**DUKE POWER COMPANY**

January 14, 1983

Re: Catawba Nuclear Station  
Docket Nos. 50-413 and 50-414

In order to facilitate the completion of the review of the Catawba FSAR, Duke Power Company is transmitting herewith responses or revised responses to open items of the following technical review branches.

Figure 2.5.2-8A  
Revision 7  
New Figure

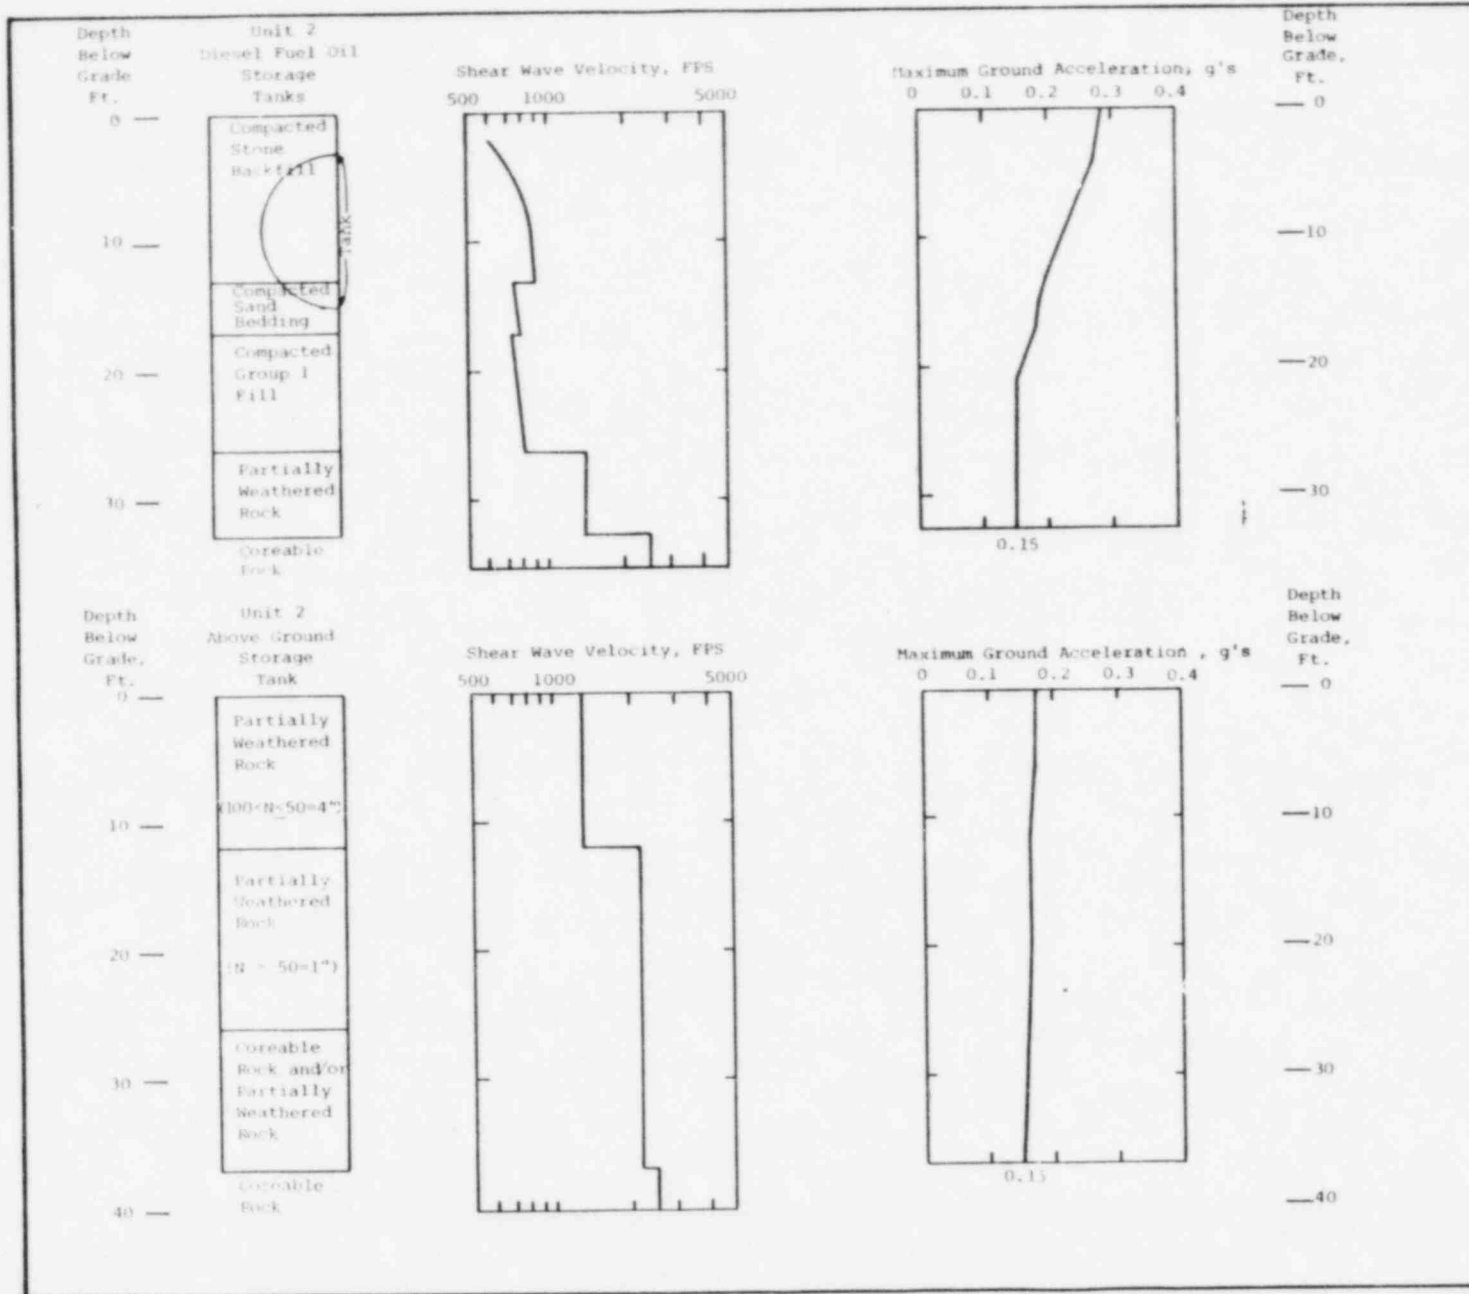
The subsurface conditions at structures listed in Table 2.5.4-4 and for which the amplified smoothed design response spectra on Figure 2.5.2-8 are used for design are summarized on Figure 2.5.2-8A. As can be seen from Figure 2.5.2-8A, the site conditions are such that only the Unit 2 Diesel Fuel Oil Tanks and the Unit 2 Above Ground Storage Tank actually justify consideration of a design response spectrum other than the one for rock on Figure 2.5.2-7. However, all the structures named on Figure 2.5.2-8A were designed using the amplified response spectrum on Figure 2.5.2-8.

Figure 2.5.2-8B  
 Revision 7  
 New Figure

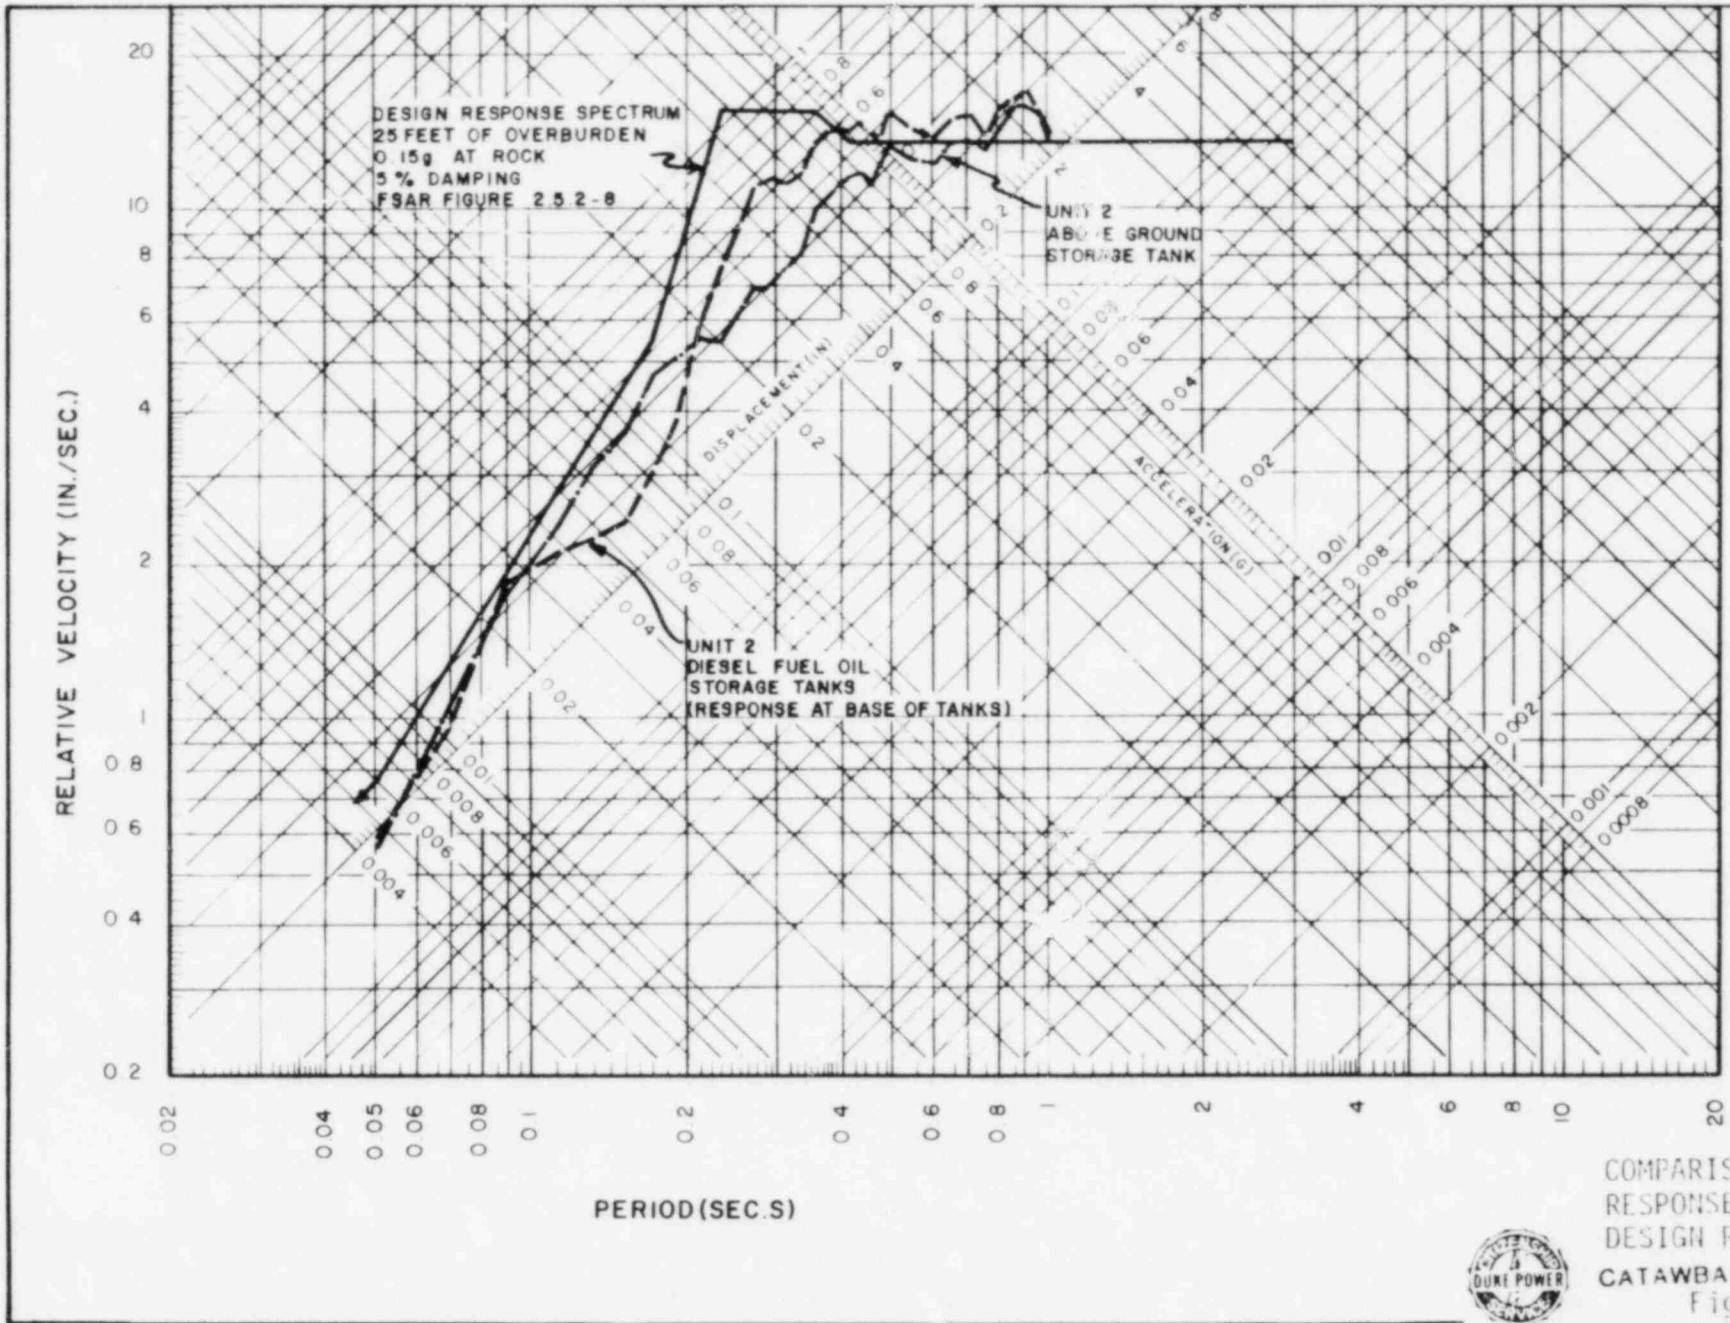
For the Unit 2 Diesel Fuel Oil Tanks and Unit 2 Above Ground Storage Tank, horizontal response spectra are calculated for the specific soil columns at the structure for comparison to the smoothed design spectrum actually used and shown on Figure 2.5.2-8. The program SHAKE is utilized for these calculations using the soil parameters shown on Figure 2.5.2-8B. The strain dependency of shear modulus and damping of all the soil and sand in the soil columns is assumed to conform to the average curve for sand found in Seed and Idriss, 1970 (Reference 102). The strain dependency of the shear modulus of the compacted crushed stone backfill is calculated using information contained in Reference 107. The shear wave velocity (shear modulus) at low strain of the compacted crushed stone is computed from information contained in Reference 107. The damping in the crushed stone is assumed to be about 15 percent less than the average sand damping at the equivalent confining pressure and shear strain.

Figure 2.5.4-14A  
Revision 7  
New Figure

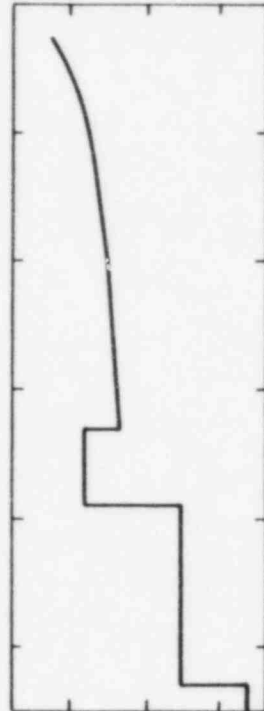
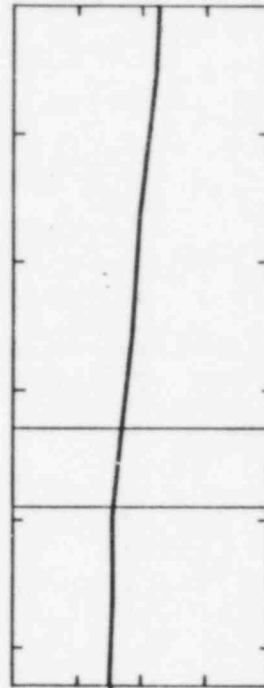
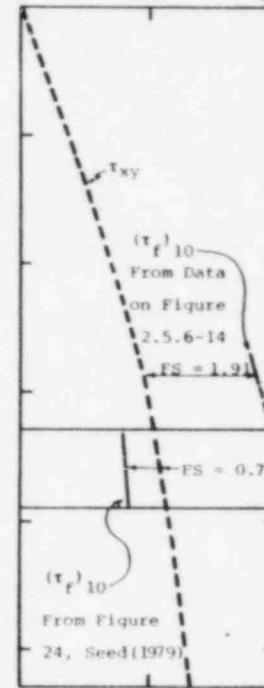
In order to evaluate the liquefaction potential of the pocket of alluvial soils encountered in boring A-138 (a single sample within the interval from 33 to 30 ft), a soil column analysis using the program SHAKE is performed to compute the cyclic shear stresses induced by the SSE (Figure 2.5.4-14A). The shear wave velocity of the compacted fill is assumed the same as from the SNSW Pond Dam (Section 2.5.6). The shear wave velocity of the alluvium is estimated from the standard penetration test value, overburden pressure, and information contained in Anderson, et al., (1978) (Reference 109). The shear wave velocity of the partially weathered rock was obtained from in-situ measurements of shear wave velocity in similar material at the Catawba site. The cyclic shear strength of the compacted fill is obtained from tests on the compacted fill for the SNSW Pond Dam, Figure 2.5.6-14. The cyclic shear strength of the alluvial sand is estimated from Figure 24 of Seed (1979) (Reference 110). As can be seen from Figure 2.5.4-14A, the cyclic shear strength of the compacted fill exceeds the induced cyclic shear stresses by a safety factor of 1.91 (minimum). The cyclic shear stresses exceeds the cyclic shear strength in the pocket of alluvial sands; thus, this localized zone of alluvial soil has a potential for pore pressures to become equal to the confining pressure during the SSE (consisting of the synthetic time histories).
